APPLICATION FOR AMENDMENT
TO
FACILITY OPERATING LICENSE NO. NPF-3
FOR
DAVIS-BESSE NUCLEAR POWER STATION
UNIT NO. 1

Docket No. 50-346
License No. NPF-3
Serial No. 994
October 11, 1983

I. Changes to Davis-Besse Nuclear Power Station Unit 1, Appendix A, Technical Specifications Sections 4.1.2.1, 4.1.2.2., 3.1.2.8 and 3.1.2.9.

B. Reason for Change (Facility Change Request 82-111 Rev. C)

FIGURE-2

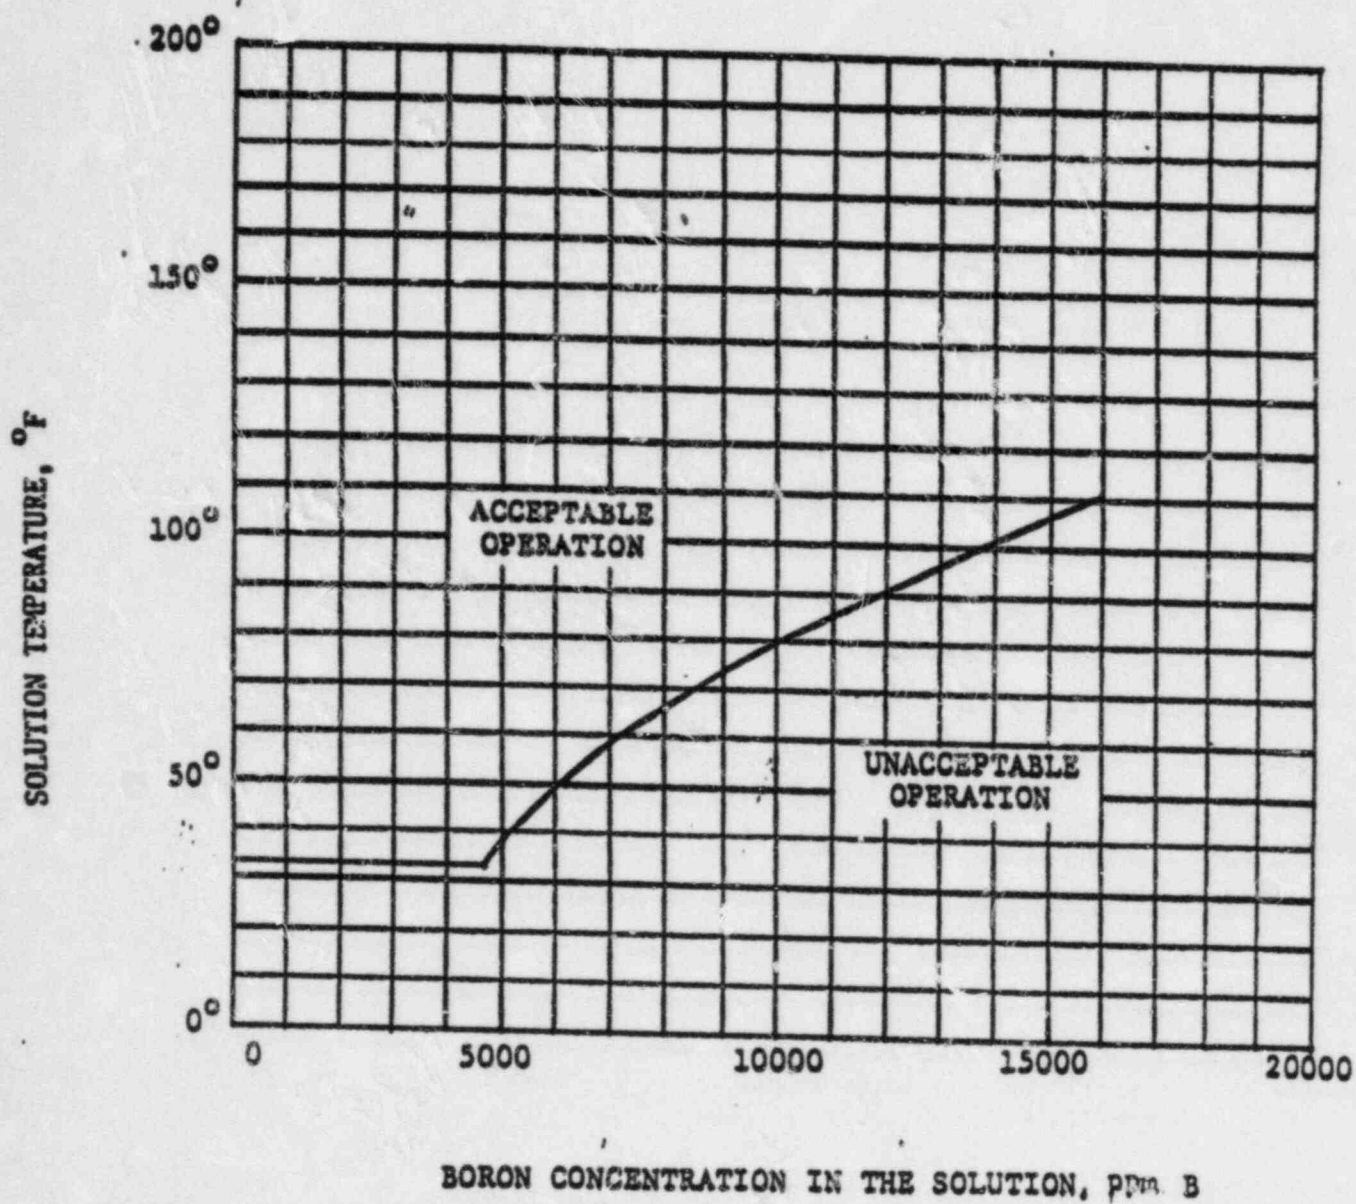
The only time the need for temperature verification exists is during and after the flow path has been used for transporting boric acid with a source concentration of >5000 ppmB. If at any time the line is used for transporting the boric acid of source concentration <5000 ppmB, the temperature need not be maintained above 105°F, since per the attached Figure 2 the crystallization will occur only below the freezing point of approximately 32°F. Thus, there is no safety concern for boric acid crystallization under those circumstances. Liquid samples are taken from the source for verification of boron concentration (not from the flow path) and this is so reflected in the revised Technical Specifications.

The proposed modification to the Technical Specifications allows for conditions when the verification of surveillance requirements is to be completed close to a time when the flow path has been or is being used to transport low boron concentration solutions. Thus, if the seven day verification of temperature falls during transfers of low boron concentration solutions, the verification period may be extended up to 8 hours after the addition of dilute boron solution has been stopped for at least 8 additional hours. This implies that the seven day temperature verification is not required if the line is being used for transport of low boron concentration water either continuously, or, intermittently as long as the time period between two successive (low boron concentration) water transports is less than 8 hours. This period is considered adequate and

included in the Technical Specifications to allow for the conduct of successive routine deborations during normal plant operation and core life. If the seven day verification falls during such transfers and the transfer is stopped for more than 8 hours, the surveillance verification has to be performed within the next 8 hours. This allows adequate time for the heat tracing to elevate and maintain the boric acid flow path temperature after the passage of cold liquids through the flow path has been stopped. Such verification will also ensure the operability of the heat tracing and further, will prevent boron crystallization should the flow path be used next for transfers of high boron concentration solutions. If the seven day verification falls during high boron concentration (>5000 ppmB) transfers, the verification requirement will be the same as in the existing Technical Specifications.
